Title of Change:	Transfer assembly and test of Ultrafast and Planar Schottky rectifier products in TO220FP package from ON Semiconductor Vietnam (OSV) to SP Semiconductor & Communication Co., Ltd (SP Semi) with case outline change.	
Proposed Changed Material First Ship Date:	29 August 2019	
Contact information:	Contact your local ON Semiconductor Sales Office or <Phuong.Hoang@onsemi.com>	
Samples:	Contact your local ON Semiconductor Sales Office or <PCN.samples@onsemi.com> Sample requests are to be submitted no later than 30 days from the date of first notification, Initial PCN or Final PCN, for this change. Samples delivery timing will be subject to request date, sample quantity and special customer packing/label requirements.	
Additional Reliability Data:	Contact your local ON Semiconductor Sales Office or <Tam.Vu@onsemi.com>	
Type of notification:	This is a Final Product/Process Change Notification (FPCN) sent to customers. FPCNs are issued 90 days prior to implementation of the change. ON Semiconductor will consider this change accepted, unless an inquiry is made in writing within 30 days of delivery of this notice. To do so, contact <PCN.Support@onsemi.com>

Comparison between

TO-220 FULLPAK
CASE 221D-03 (SP Semi)

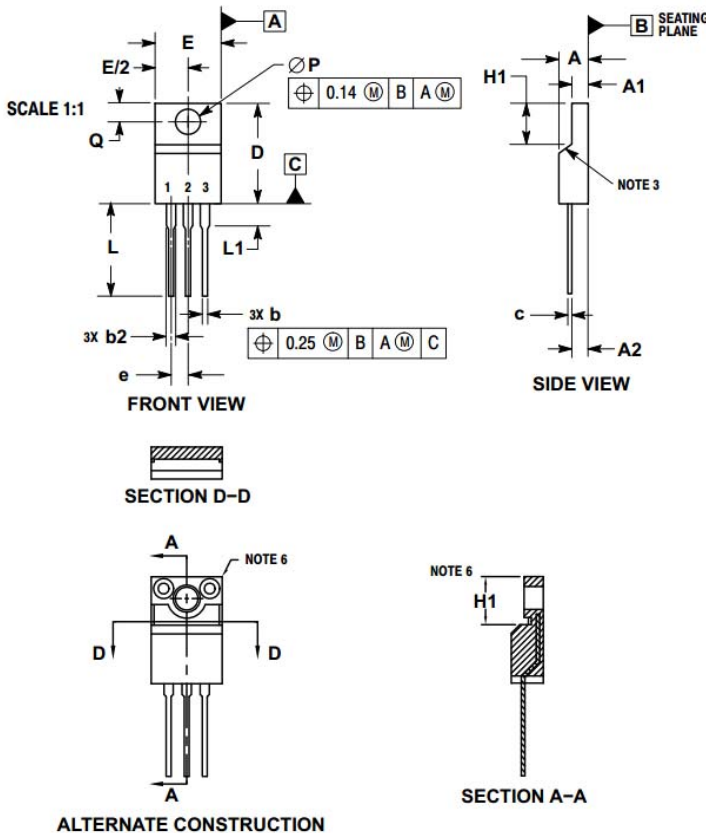
ケース外形の比較
